Re: Petition No. 1354 – Chatfield Solar Fund, LLC, petition for a declaratory ruling, pursuant to Connecticut General Statutes §4-176 and §16-50k, for the proposed construction, maintenance and operation of a 1.98-megawatt AC solar photovoltaic electric generating facility located in Killingworth, Connecticut

Interrogatory CSC-1-1

Chatfield Solar Fund, LLC
Petition No. 1354

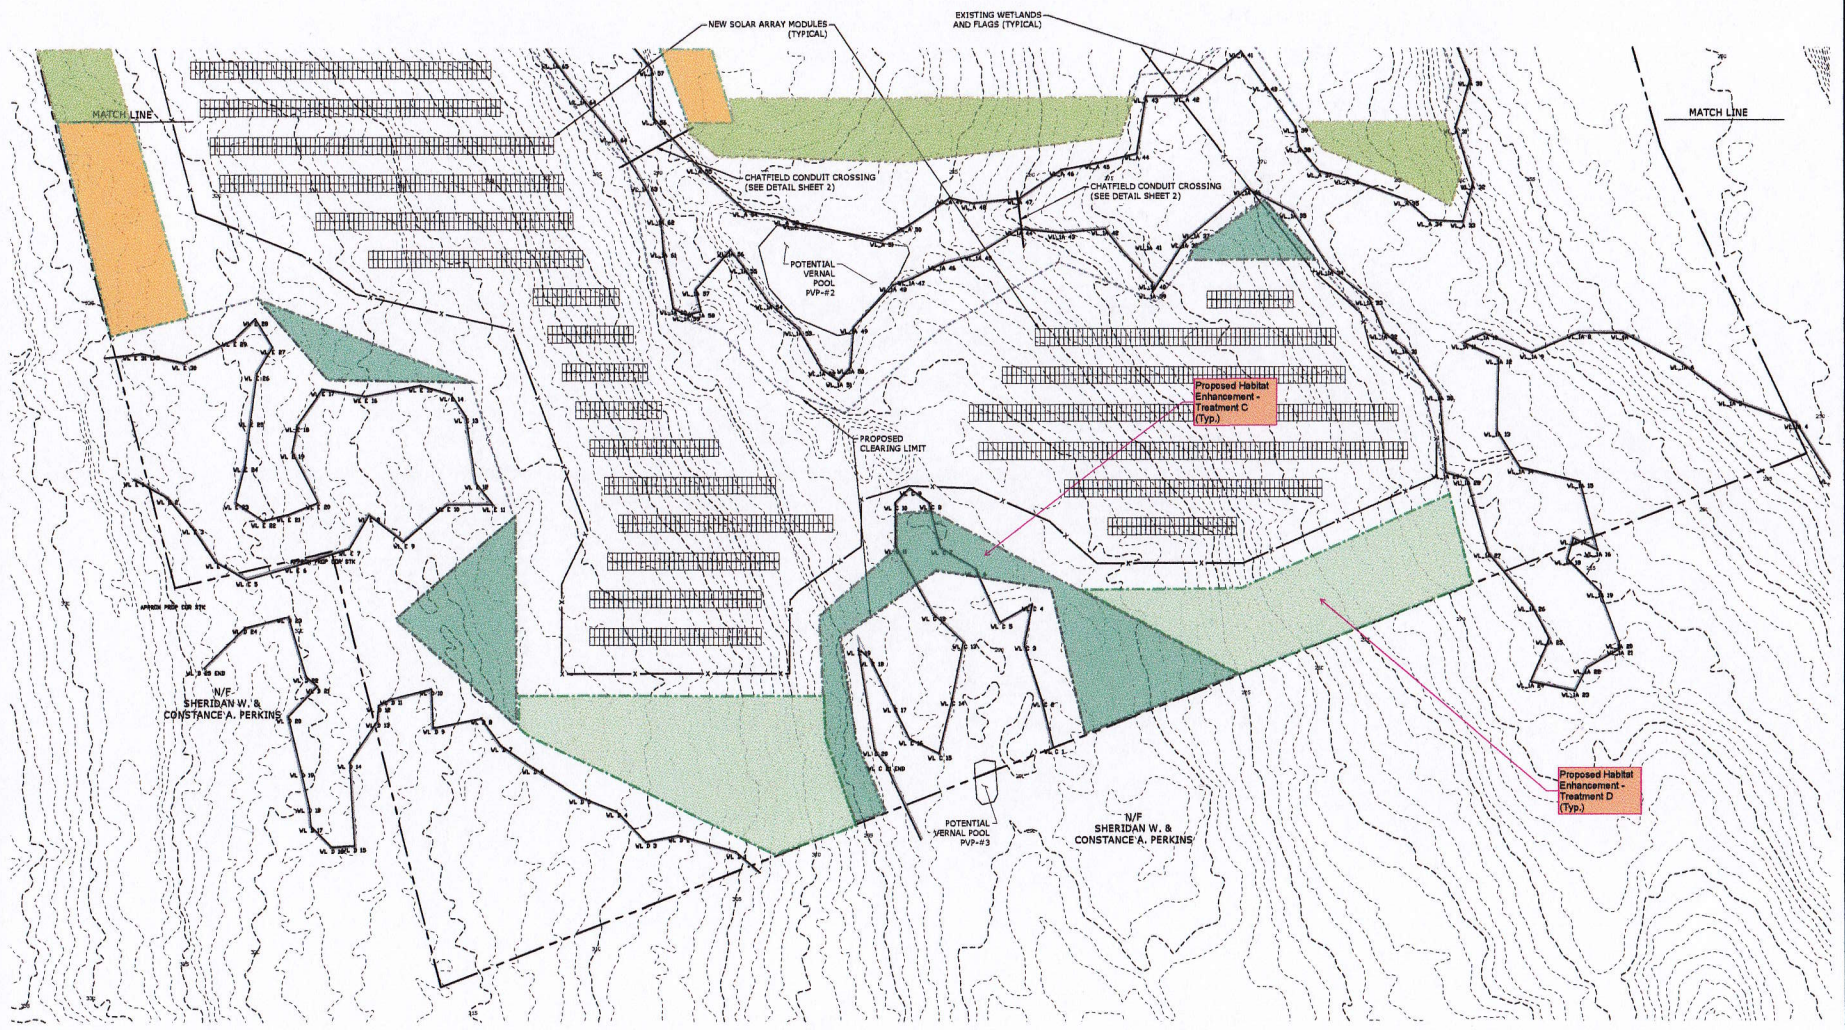
Q-CSC-1-18: Provide the direction/distance on a scaled map from the solar field perimeter fence to the nearest property line and to the nearest residential structure.

Q-CSC-1-37: Petition Environmental Assessment. p. 3-1 states the Project area contains moderate slopes. Petition Site Plan Sheet 2 states steep slopes are present in the construction area. Please clarify. What is the steepest slope within the eastern portion of the construction area? Would grading be required to create slopes conducive to the installation of the solar racking system? If so, identify areas of grading.

A-CSC-1-18: Please see **Attachment CSC-1-18** (the "Site Plan").

A-CSC-1-37: Site Plan 1B depicts a moderate slope (see **Attachment CSC-1-18**). The steepest slopes on the site are 40% on the western edge of the eastern wetland area. There are no solar arrays in this area, although there are small pockets of steep slopes in other areas of the site where arrays are located. No grading is required for the project site.

FIGURE 2: North Branford Road, (Route 80), Killingworth, CT

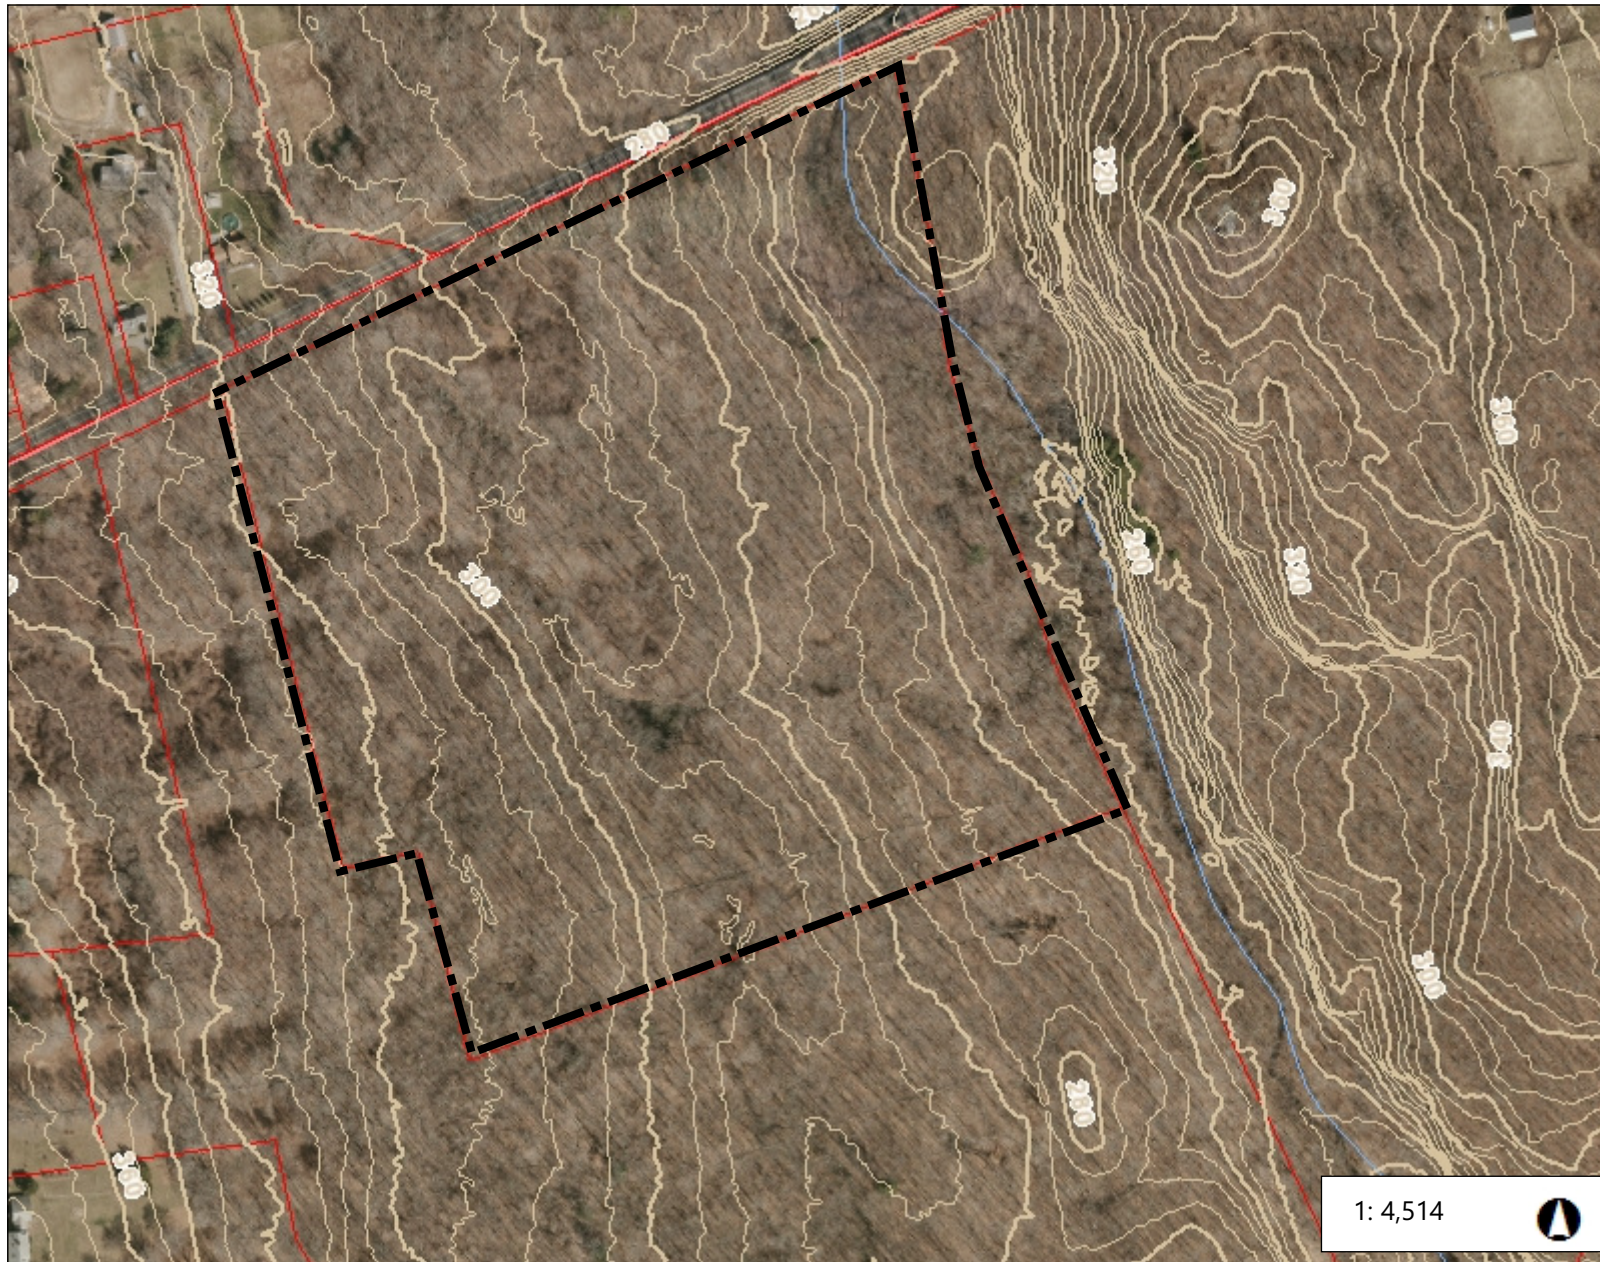
- a) Figure 2 does not appear to show the whole site, please revise.
- b) The legend for Figure 3 is partially shown, please provide the entire legend.
- c) Revise Figure 3 to include designated Wetland Numbers.
- d) If possible, identify the locations of the photos 1 through 14 on Figure 3.
- e) Page 13 mentions temporary wetland matting. Provide a detail of the temporary matting system to be used.
- f) Page 14 mentions general impact to vernal pool envelope (VPE) and the critical terrestrial habitats (CTH) for the on-site 3 vernal pools. Calculate the impact to the VPE and CTH for each vernal pool.

- A-CSC-1-55:
- a) Figure 2 has been revised and is submitted as **Attachment CSC-1-55-1**.
 - b) Figure 3 is revised and is submitted as **Attachment CSC-1-55-2**.
 - c) Figure 3 now provides designated Wetland Numbers (see **Attachment CSC-1-55-2**).
 - d) It is not possible to provide exact locations of photographs. Refer to photo annotations in Wetlands Assessment for the general location and direction of viewing.
 - e) See **Attachment CSC-1-55-3**.
 - f) See the table below:

NOTE: 20' SECTIONS OF EATON B-LINE NEMA 20C OR EQUIVALENT OUTDOOR RATED CABLE TRAY MUST ABLE TO SUPPORT AT LEAST 100LBS/FT OF WORKING LOAD.

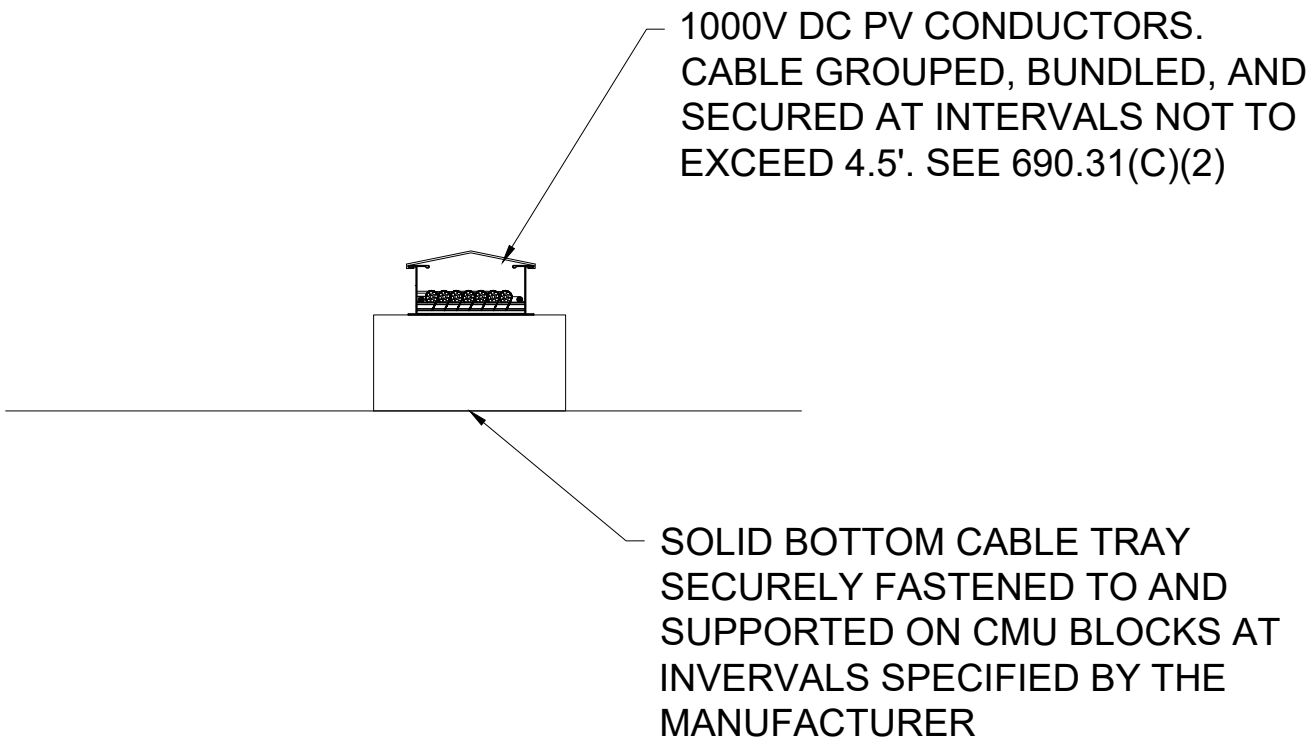
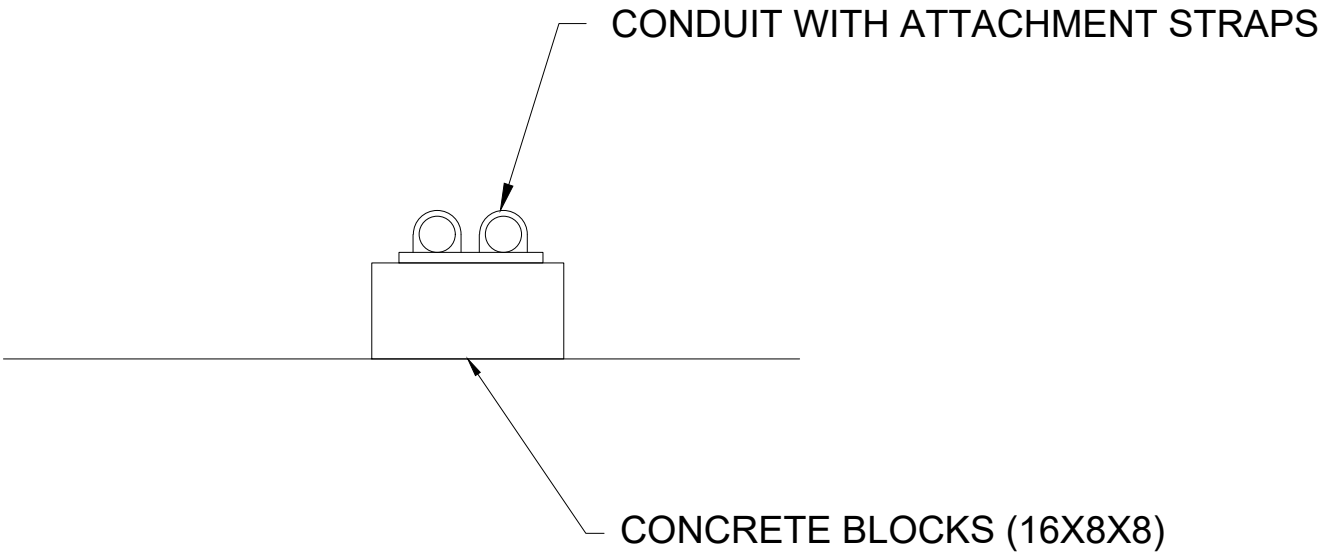
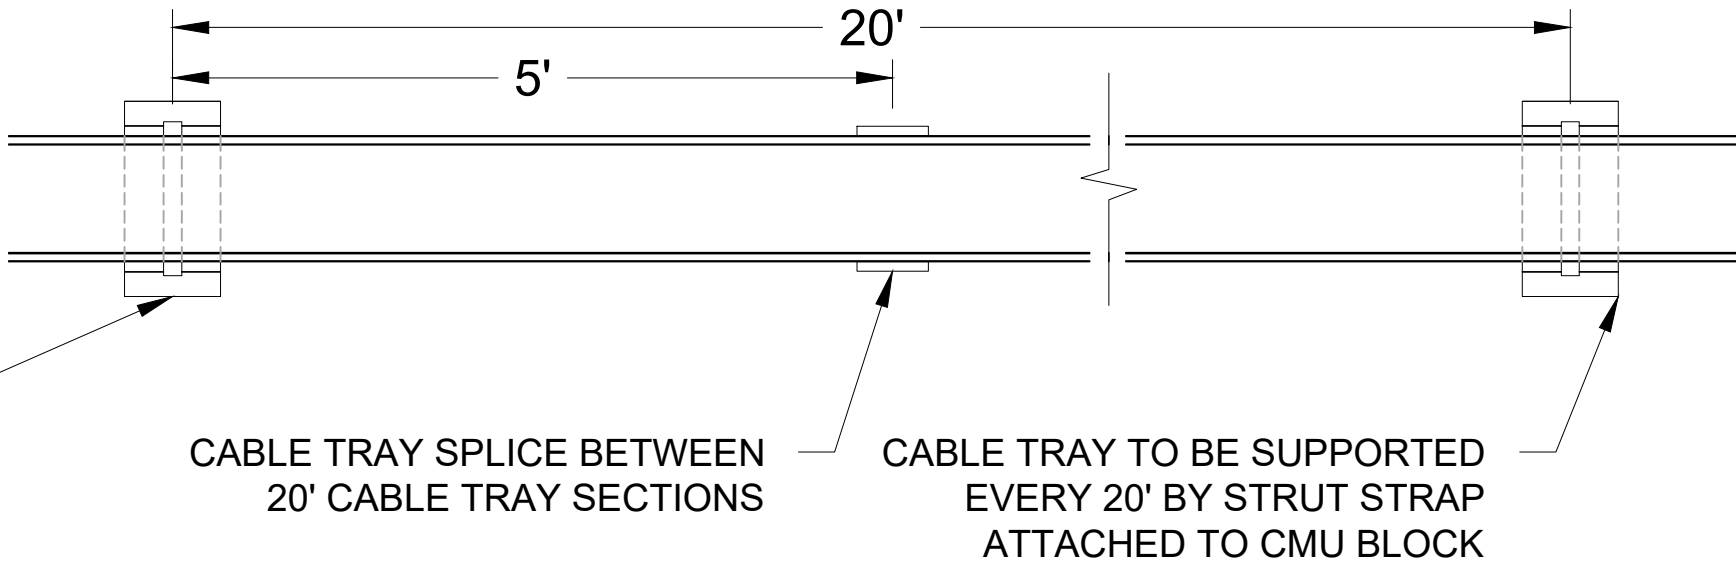
Q-CSC-1-77: Referring to Petition Site Plan Sheets, conduit wetland crossings, provide the following:

- a) Describe the equipment necessary to install the conduit crossings.
- b) What is the expected wetland impact during construction of both conduit crossings?
- c) Is tree/vegetation clearing necessary to install the conduit crossings? If so, include on the Site Plan. How would clearing be accomplished?
- d) Provide detail as to how the electrical cable extends from underground to the above ground.
- e) Is the design of the conduit crossing susceptible to damage from fallen trees?
- f) What crossing height above both wetlands is necessary to avoid potential inundation of the conduits?

- c) Please see the attached Site Plan for details on the conduit crossing. Please see **Attachment CSC-1-77**.
 - d) There are no underground conduits planned for the solar facility except from the Eversource transformer. Underground conduits to the Eversource transformer are stubbed up under the transformer pad to the transformer connection cabinet.

- f) Conduits are planned to be installed above the water level at a minimum height of 18" above the wetland area.
